Product Change Notice (PCN)

PCN Number: PCN-0450915R-01

Product(s) Affected: SJ1-2513-SMT-TR & SJ1-2515-SMT-TR

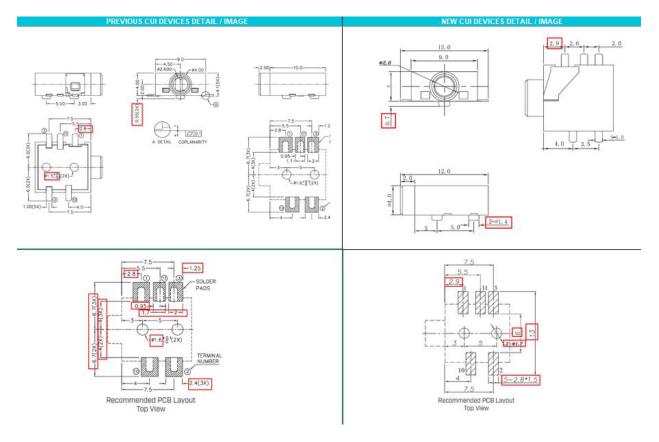
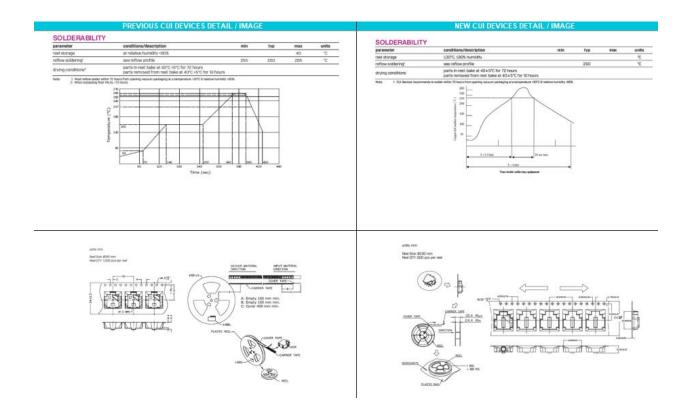
Description of Change: Minor Housing and footprint differences. Material Change on the housing and terminals. See image Below

PREVIOUS CUI DEVICES DETAIL / IMAGE

01.471010
	MATERIAL	PLATING
terminal 1	copper alloy	gold flash
terminal 2	copper alloy	gold flash
terminal 3	copper alloy	gold flash
terminal 10	brass	gold flash
terminal 11	brass	gold flash
plastic	PA10T

NEW CUI DEVICES DETAIL / IMAG

DESCRIPTION	MATERIAL	PLATING/COLOR
terminal 1	brass	gold
terminal 2	BE-CU	gold
terminal 3	BE-CU	gold
terminal 10	brass	gold
termianl 11	brass	gold
housing	PAGT	black
